PRODUCT: TOP DRIVE

DATE: April 14, 2011

SUBJECT: Replacement Rotary Manifolds

MODELS: 8050,1050,1250 with 6.81 & 7.12 gear ratio, 1275, 6027

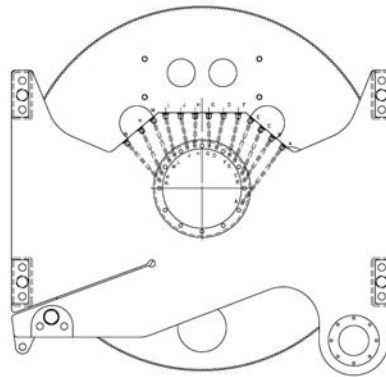
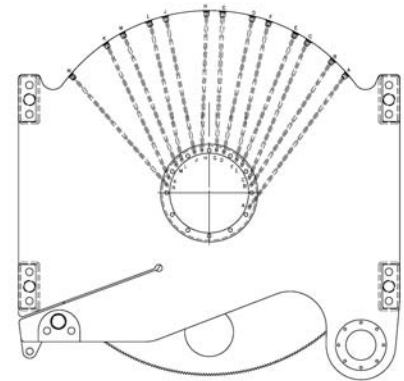
DISCUSSION: In an effort to improve top drive reliability, Canrig has modified the rotary manifold mounting plate on select models. They now have a larger radius where the hydraulic fittings attach to the ports. These new mounting plates can be installed on existing units but require a change in hydraulic fittings and hoses. The old mounting plates have been discontinued.

OLD STYLE

NEW STYLE

When ordering a replacement mounting plate, place an order for the mounting plate specified in the parts book. If it is a discontinued part, you will receive the new part with all the hoses and fittings required to install. If it is the new style, you will receive the replacement part as ordered.

When ordering a replacement rotary manifold, place an order for the rotary manifold specified in the parts book. If it is a discontinued assembly, you will receive the new assembly with all the hoses and fittings required to install. If it is the new style, you will receive the replacement part as ordered.
